Service letter NO. 2
Model effected See Des M-4 & M-4
Serial number effected 3-55

SERVICE LETTER #2 - COMPLIANCE RECORD

BOTTOM VIEW TYPICAL BOTH SIDES

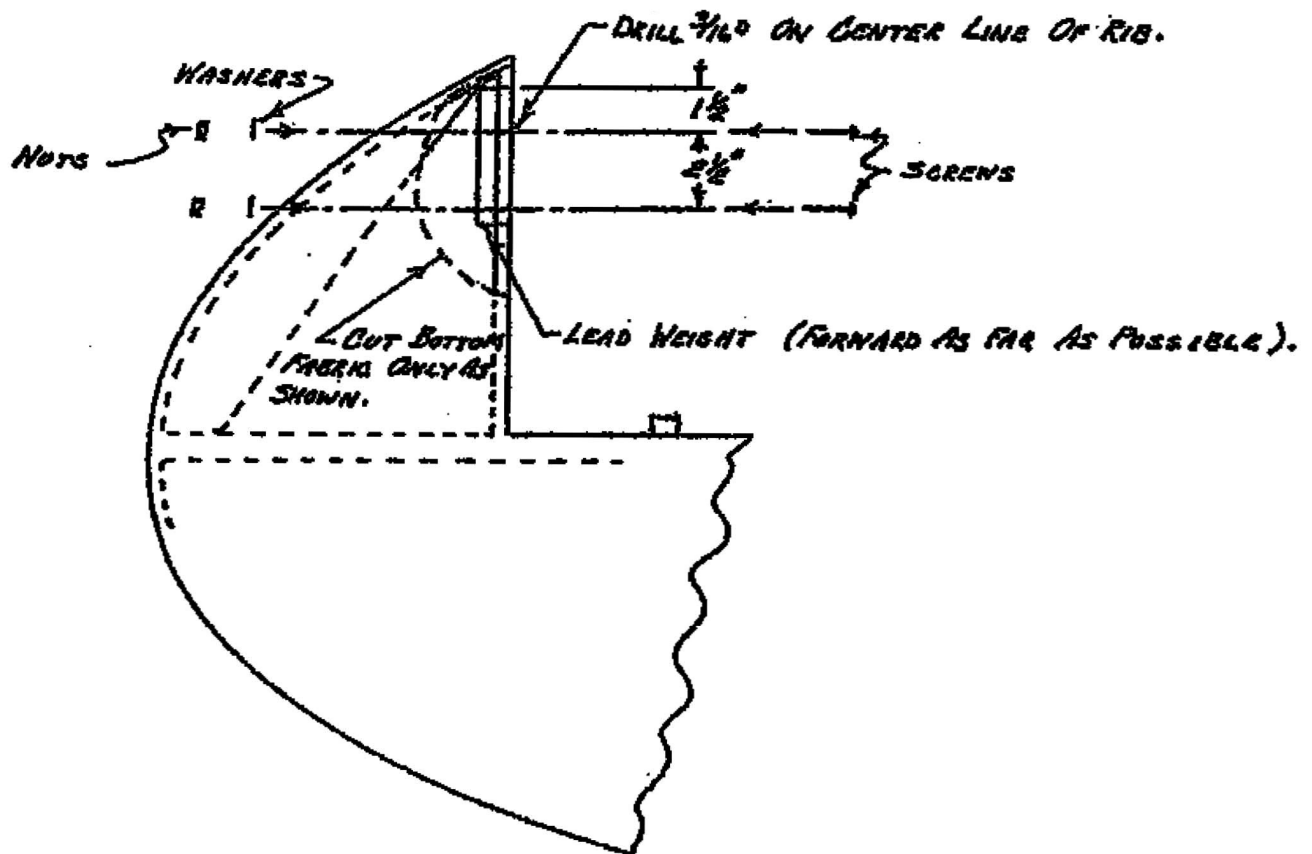
It will be required to add a balance weight to the elevator of your aircraft. I am forwarding with this letter the required weight, attaching hardware and installation drawing.

1. Remove fabric from bottom of elevator as shown on drawing.
2. Install lead weight as far forward as possible and clamp it to the rib for drilling.
3. Drill the two $3/16$ holes at the locations noted on the drawing.
4. Install the screws, washers and nuts as noted.
5. Recover out cut area as per CAM18.

1. Lead Weights (2 req'd) (per dwg CD-A560).
2. Screws AN526-10-R24 (4 req'd)
3. Nuts AN365-1032 (4 req'd)
4. Washers AN960-10 (4 req'd)
5. Fabric covering and dope. (use butyrate dope).
